Record of Decision
Morse Industrial Corporation Site
Operable Unit No. 3
State Superfund Project
City of Ithaca, Tompkins County, New York
Site Number 755010

October 2010

Responsiveness Summary

**Operable Unit No. 3 - Partial View
Approximate Boundaries**

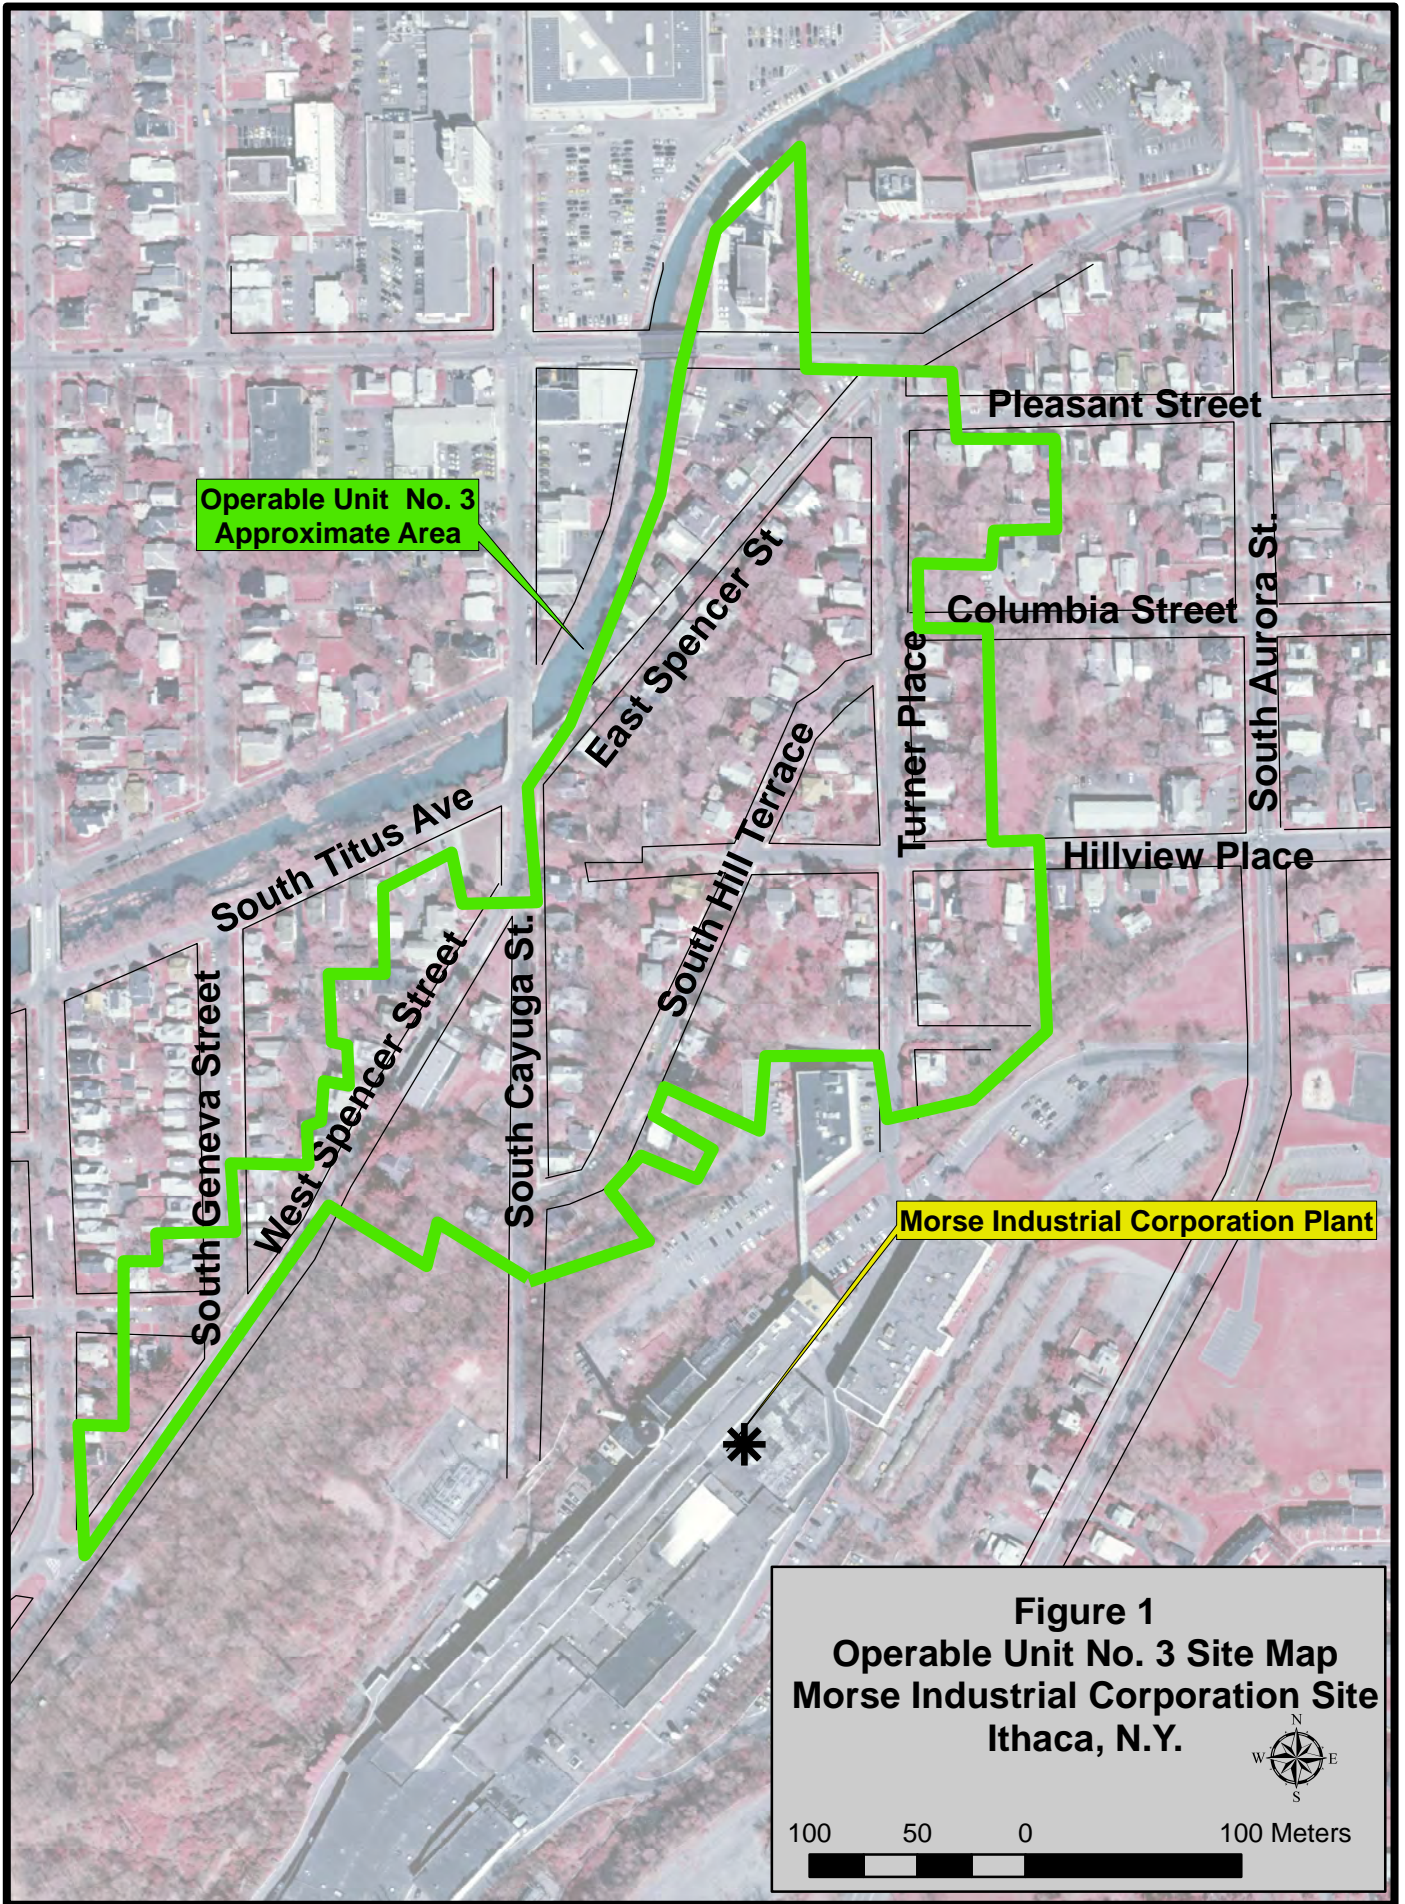
In paragraph one, line one, the site is defined as follows: “The Morse Industrial Corporation site occupies 100 acres along the west side of South aurora Street/Danby Road (Route 96B) in the South Hill portion of the city of Ithaca, Tompkins County, New York (Figure 1).” Figure 1, on Page 15, is titled “Site Map” and includes two delineations, one labeled “Plant Site” and one labeled “OU NO. 3 Approximate Area.” The figure is inaccurate as it does not show the entire Plant Site, the Plant Site boundary line is approximate, and the figure includes OU No. 3 (later defined in paragraph two). The figure and title should be revised and labeled appropriately. In addition, the delineation of the Plant Site on Figure 5 should also be revised and labeled appropriately.

RESPONSE 9: The titles of both Figures 1 and 5 have been revised, and the yellow line has been removed. The intent of Figure 1 is to show the “plant site” in relation to OU No. 3, therefore the entire “plant site” is not shown.

Figure 4
Conceptual Site Model
OU No.3
Emerson Power Transmission
Ithaca, N.Y.

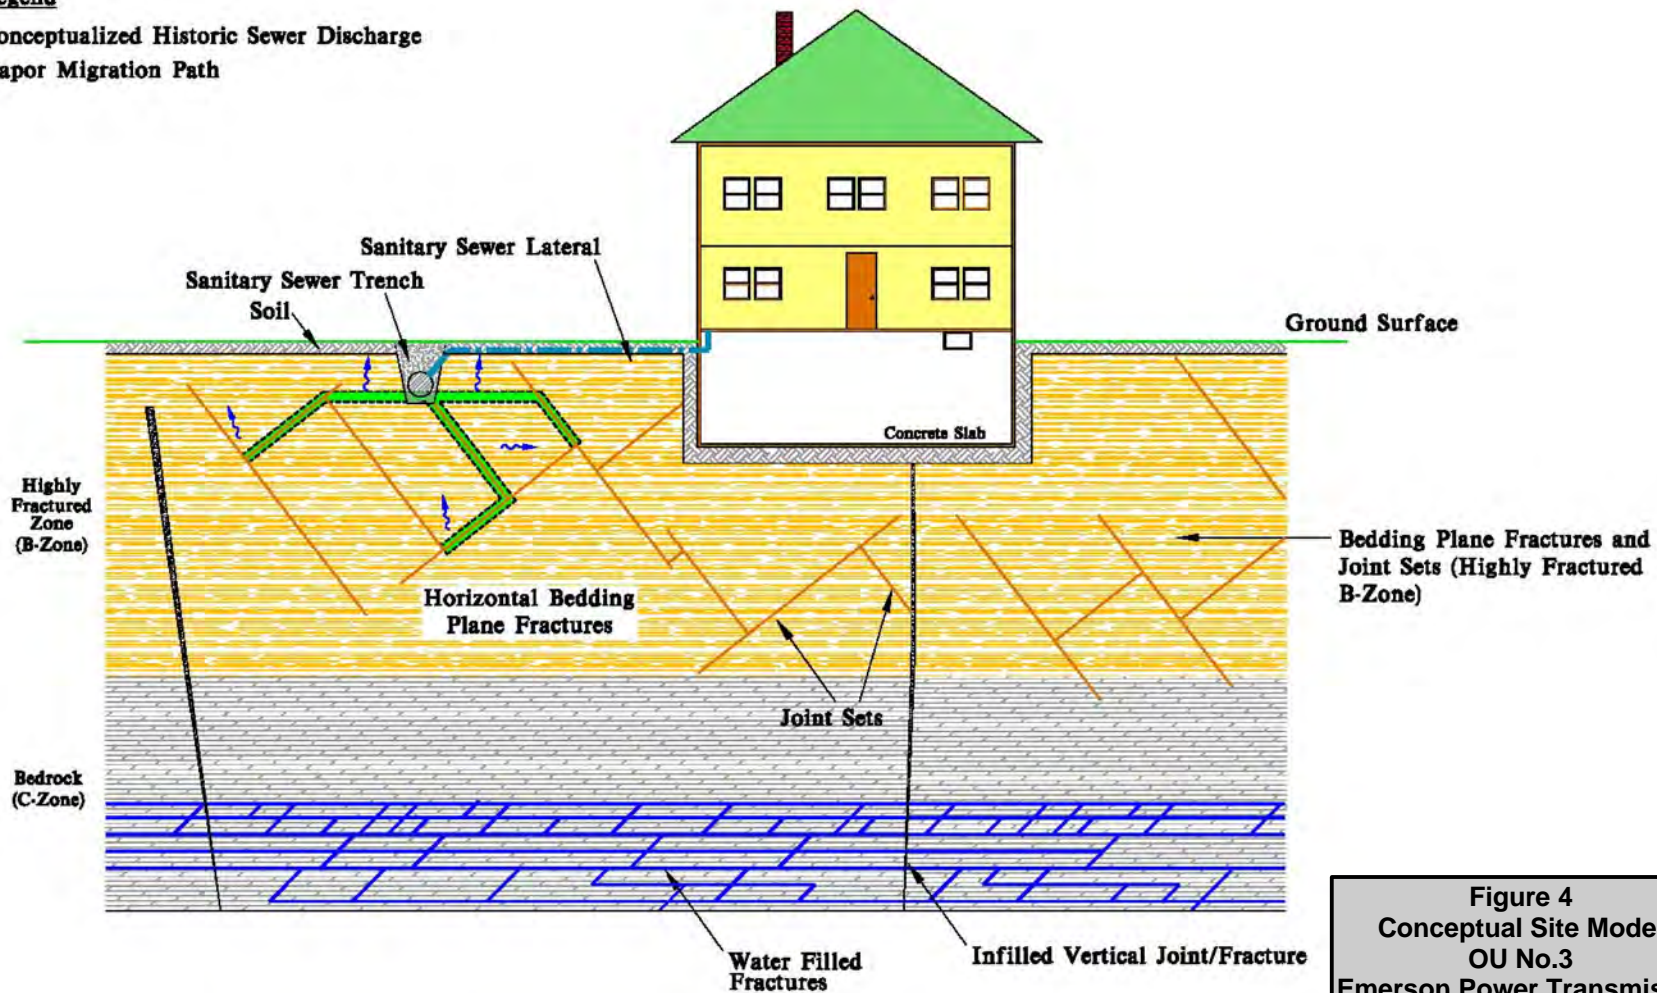
Item 2, bullet 3, states “Initial soil vapor intrusion assessments of private residences and public structures (Phases I through V, Figure 4) completed in March 2007.” Since this refers to the indoor air sampling phases conducted in OU No. 3, Figure 3 (Vapor Intrusion Investigation Phases) should be referenced rather than Figure 4 (Conceptual Site Model).

Paragraph one, line one, refers to discharges to the “municipal sewer system”, whereas, Section 2.2 previously referred to discharges to the “sanitary sewer system.” To be consistent, Section 5.1.2 should be revised to indicate “sanitary sewer system.” Line 12 in the same paragraph discusses the conceptual model for vapor transport in the subsurface and references Figure 3 (vapor intrusion investigation phases). Figure 4 should be referenced as it illustrates the conceptual site model.

Paragraph five, line one, under subheading “Soil Vapor Intrusion,” references Figure 4 which shows the conceptualized historic sewer discharge to the subsurface. As line one is discussing the five phases of indoor air sampling conducted between the fall of 2004 and winter of 2006/2007, it would be more accurate to reference Figure 3 which delineates the five sampling phases.

RESPONSE 11: The text has been modified accordingly.

Paragraph 5: The text has been modified accordingly.
